Land Use Compatibility Statement

1A. Applicant Name: Tukwila Development, LLC	1B. Project Name: Marion Pointe* (Macadam at Tukwila- pending)
Contact Name: John Raugust	Physical Address: No Situs
Mailing Address: 12965 SW Herman Rd, Suite 100	City, State, Zip: Woodburn, Oregon, 97071
City, State, Zip: Tualatin, Oregon, 97062	Tax Lot #: 502
Telephone: 503-563-6151	Township: 05S Range: 01W Section: 06
Tax Account #: 512730	Latitude: 45.163491
	Longitude: -122.851458

Subdivision - 87 Lots

The request is for annexation, zone change, planned unit development (PUD), and property line adjustment followed by preliminary subdivision to develop a defunct orchard into 87 houses on small lots with several common area tracts as open space privately owned and maintained by a homeowners association (HOA) and two local street connections with N. Boones Ferry Road. The subject property is approximately 39.69 acres, including the existing Oregon Golf Association (OGA) golf course to remain.

Exhibit PUD-3f: Site Plan Sheet P-26 Sidewalks (blue: min 8 ft wide); see Attachment 103 for full size

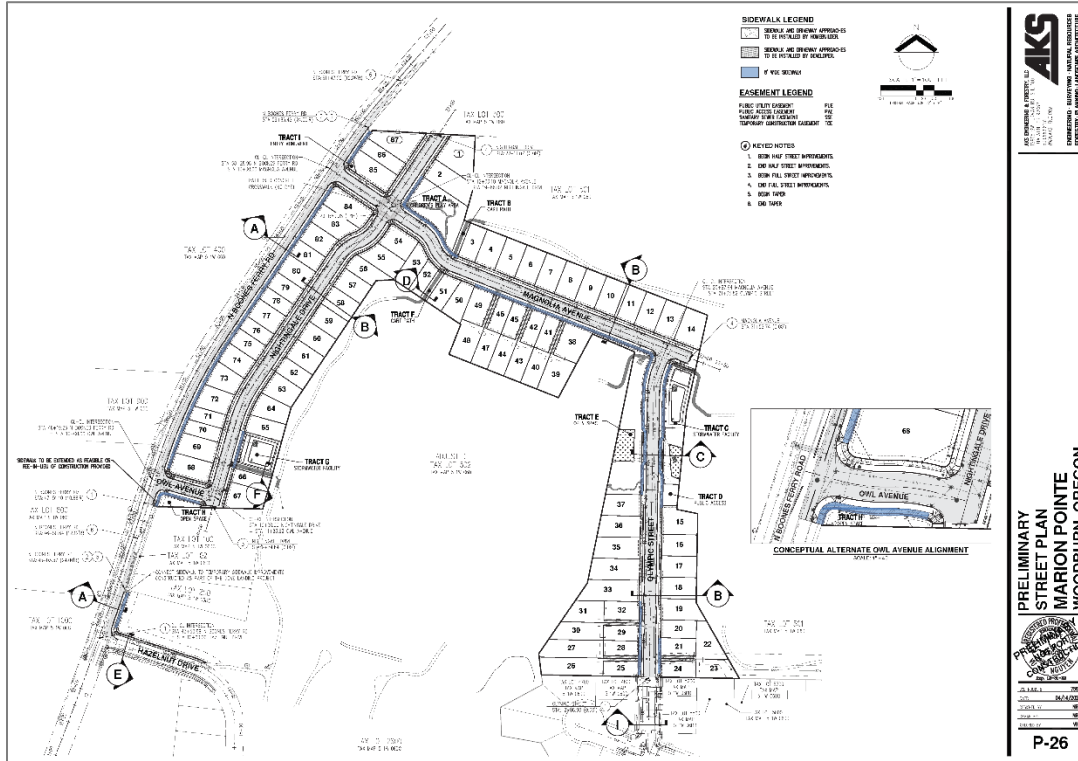
- f. Sidewalks: Min 6 ft wide except wider as Exhibit PUD-3f supersedes. BFR sidewalk southerly and two northerly dead-ends shall have ADA-compliant transitions spanning between sidewalk and road shoulder as the applicable public works authority specifies. The segment extending north from Hazelnut sidewalk may meander, including PUE overlap, and taper to 6 ft through RPZs to save most of the loose row of trees along the road.

Exhibit PUD-3f: Site Plan Sheet P-26 Sidewalks (blue: min 8 ft wide); see Attachment 103 for full size

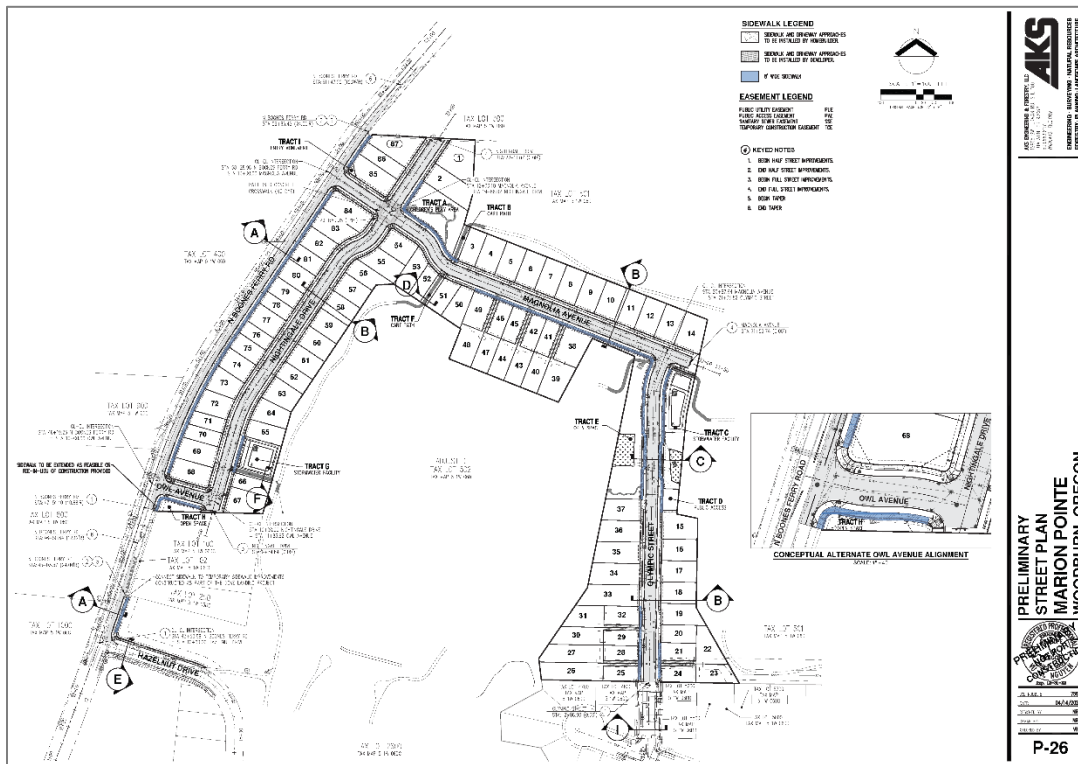
- f. Sidewalks: Min 6 ft wide except wider as Exhibit PUD-3f supersedes. BFR sidewalk southerly and two northerly dead-ends shall have ADA-compliant transitions spanning between sidewalk and road shoulder as the applicable public works authority specifies. The segment extending north from Hazelnut sidewalk may meander, including PUE overlap, and taper to 6 ft through RPZs to save most of the loose row of trees along the road.

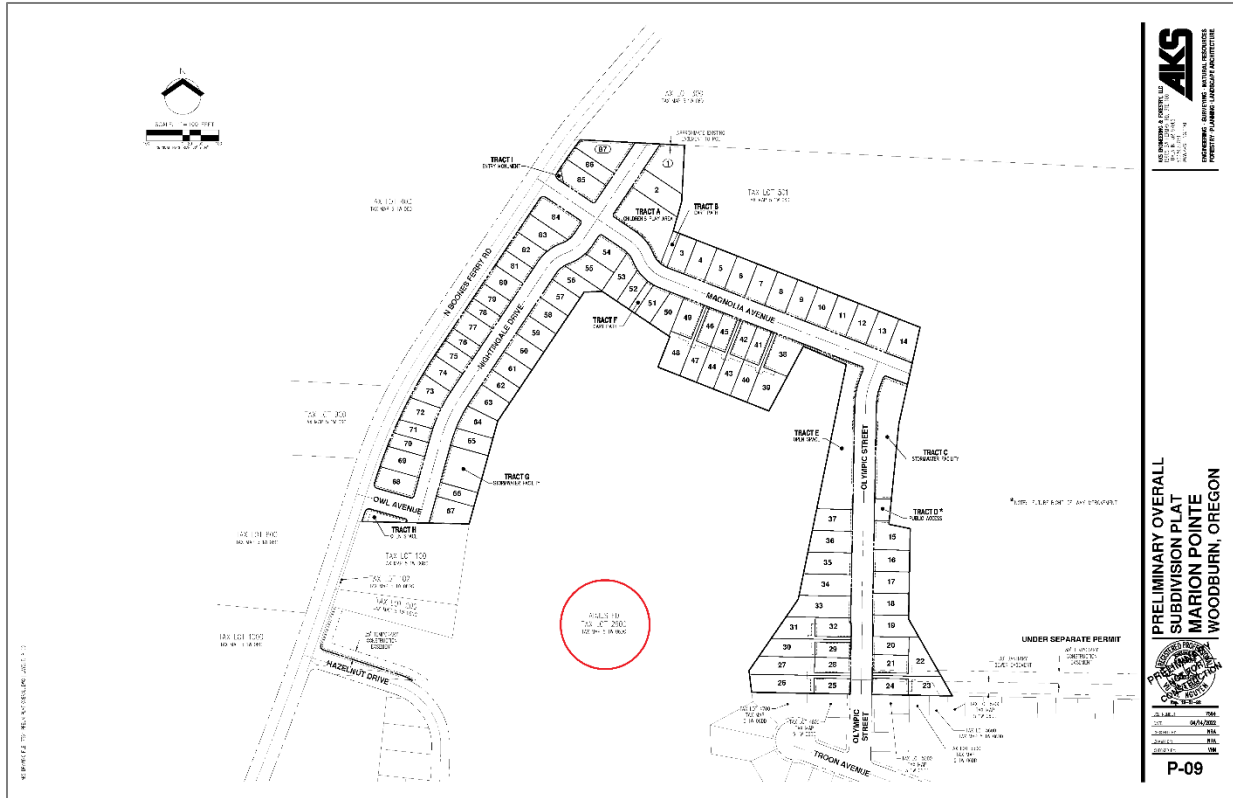
The proposal through PLA 22-02 is to adjust the northerly boundary of Tax Lot 051W06DC02600 so that the golf course remains on its own lot. Below is an excerpt of land use review Sheet P-09 with the adjusted tax lot labeled circled in red, and Sheet P-08 shows the adjustment.

Exhibit PUD-3f: Site Plan Sheet P-26 Sidewalks (blue: min 8 ft wide); see Attachment 103 for full size

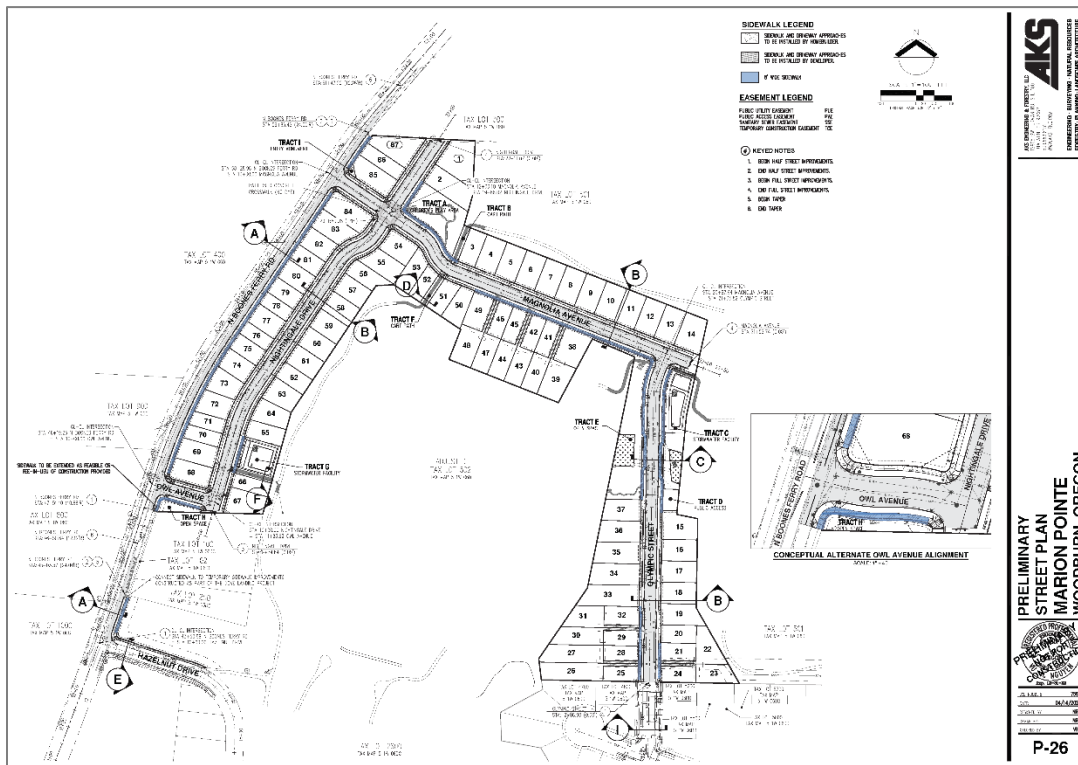
- f. Sidewalks: Min 6 ft wide except wider as Exhibit PUD-3f supersedes. BFR sidewalk southerly and two northerly dead-ends shall have ADA-compliant transitions spanning between sidewalk and road shoulder as the applicable public works authority specifies. The segment extending north from Hazelnut sidewalk may meander, including PUE overlap, and taper to 6 ft through RPZs to save most of the loose row of trees along the road.

Exhibit PUD-3f: Site Plan Sheet P-26 Sidewalks (blue: min 8 ft wide); see Attachment 103 for full size

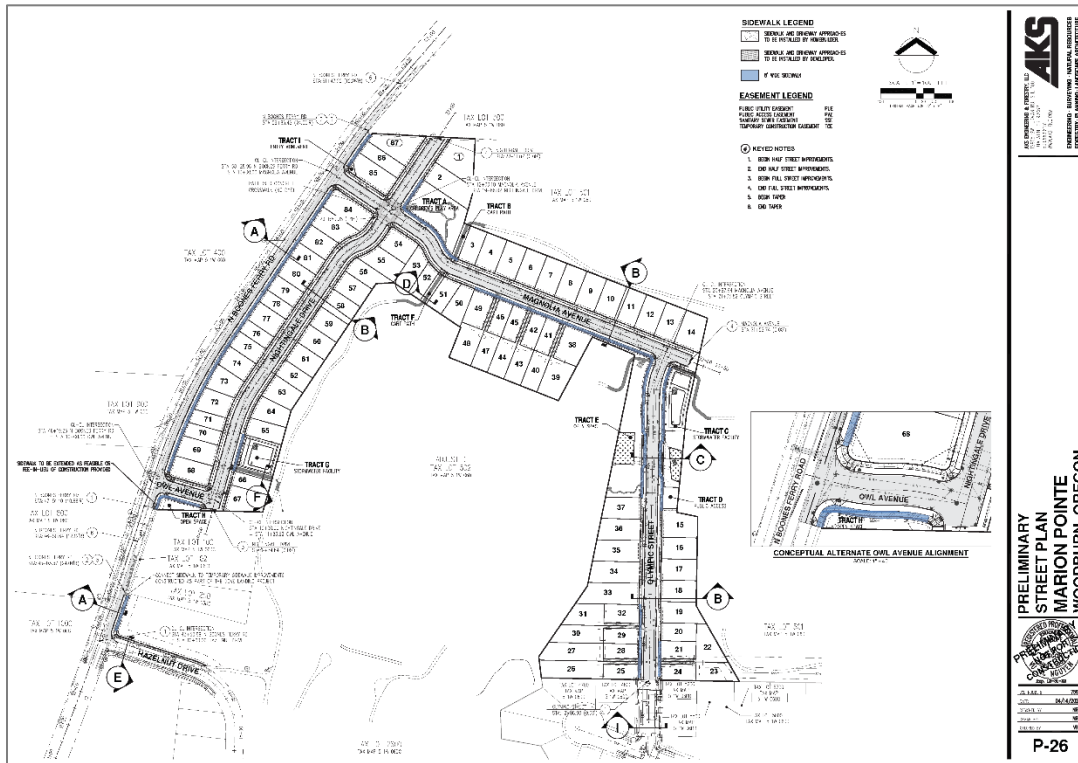
overlap, and taper to 6 ft through RPZs to save most of the loose row of trees along the road.
